Allied-Signal Inc.
Engineered Materials Sector
Fluorine Products Division
P.O. Box 430
Metropolis, IL 62960
Telephone (618) 524-2111

Subject: License No. SUB-526
Docket No. 40-3392

In response to your telephone inquiry of March 10, 1993, we are providing the following additional information regarding our request for a license amendment which was dated January 17, 1992:

FIGURE C-2.1

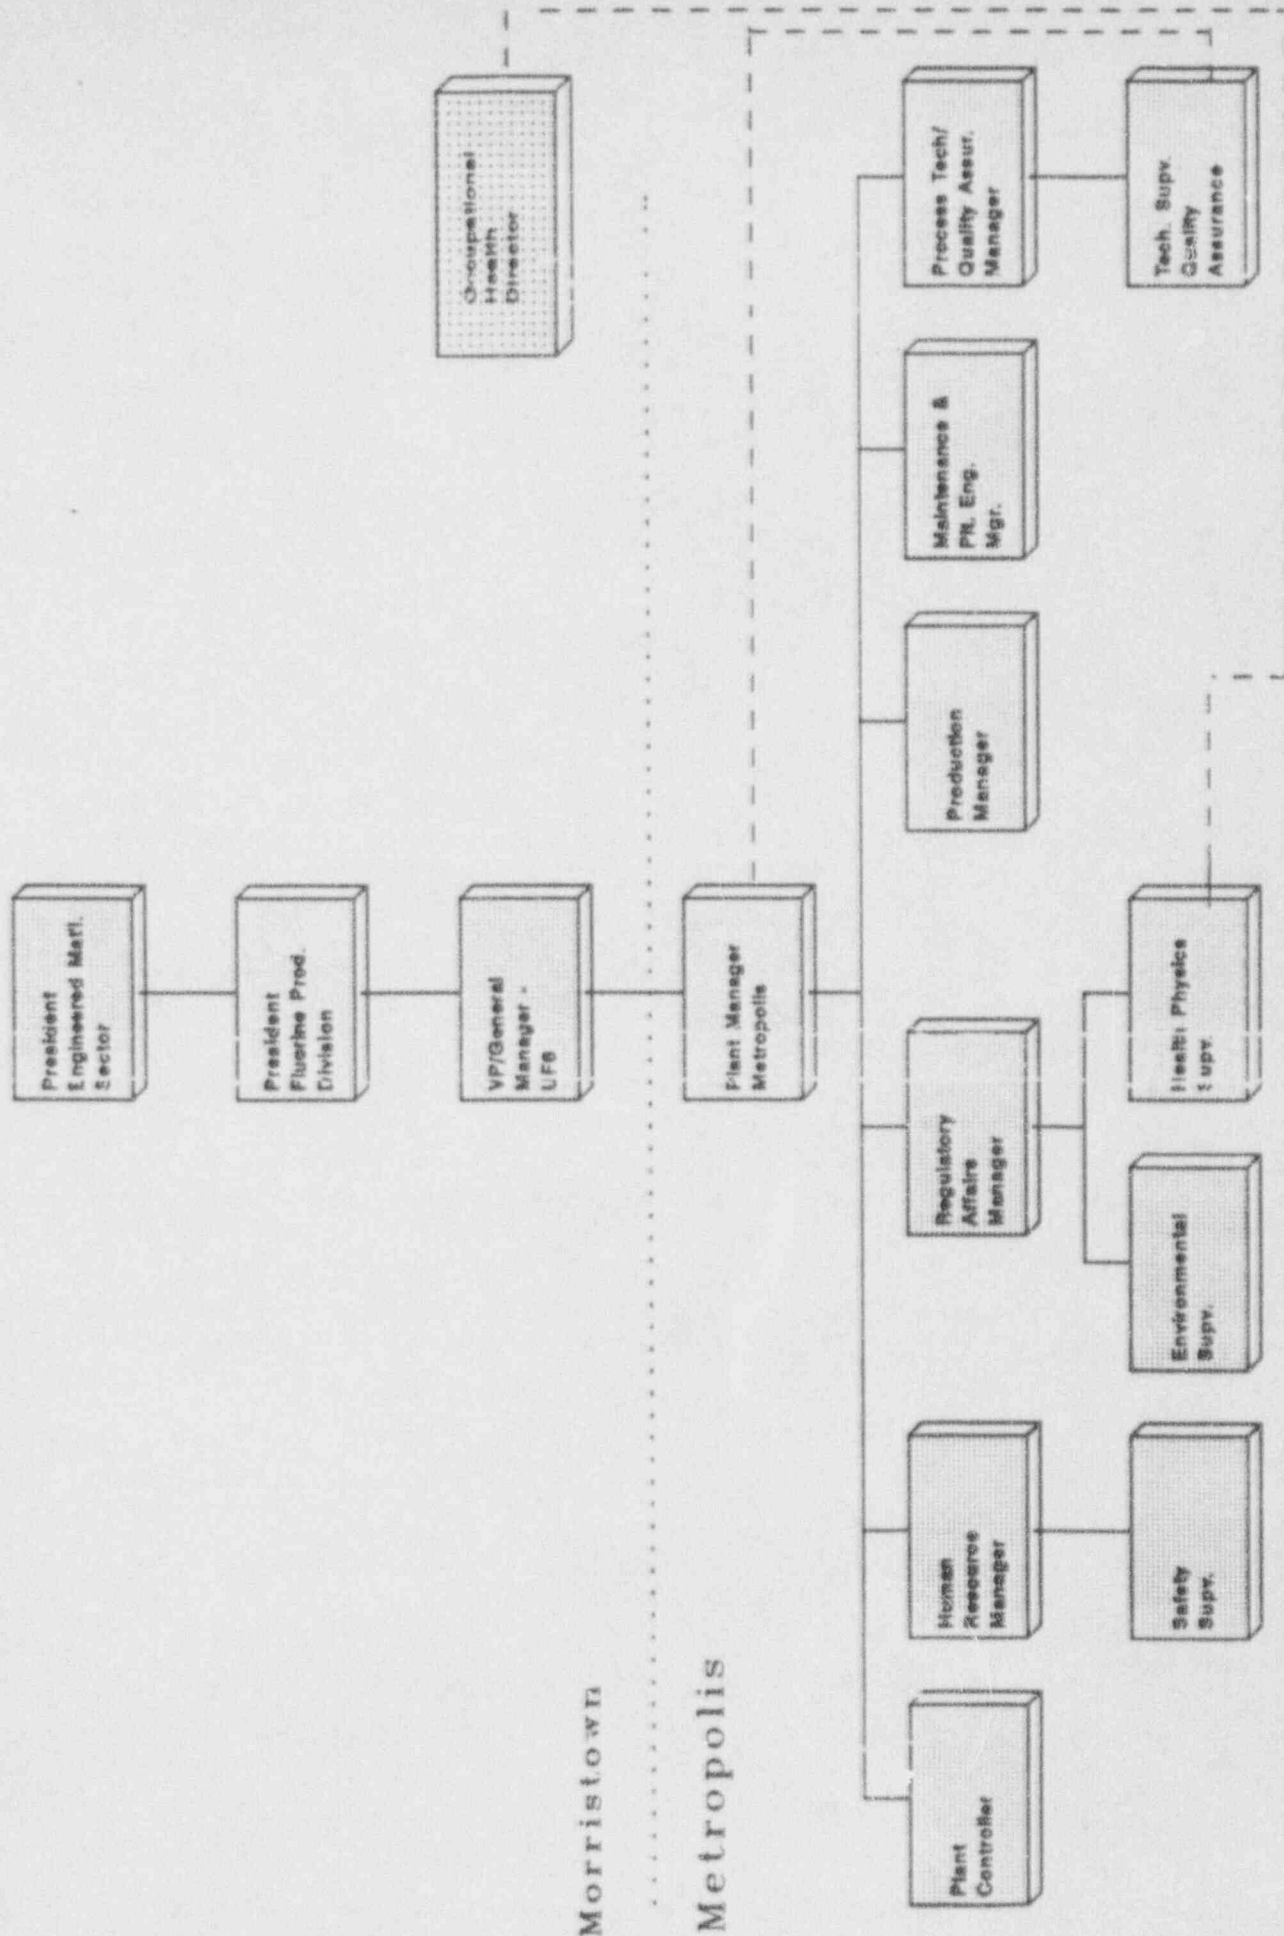
1. The organizational changes transfer responsibility for the plant Safety and Medical Program to another Department. In addition, the new organization now includes a Health Physics Supervisor, and two (2) Health Physics Specialists with additional responsibility for the Radiation Protection Program. Prior to this change the license described two positions: a "Health Physicist", and "Assistant Health Physicist". These changes will allow our Regulatory Affairs personnel to focus more on NRC and EPA requirements.

The Manager of Regulatory Affairs is responsible for compliance with regulatory requirements related to environmental pollution control, and radiation protection. This Manager has two Supervisors reporting directly to him: Environmental Supervisor, and the Health Physics Supervisor.
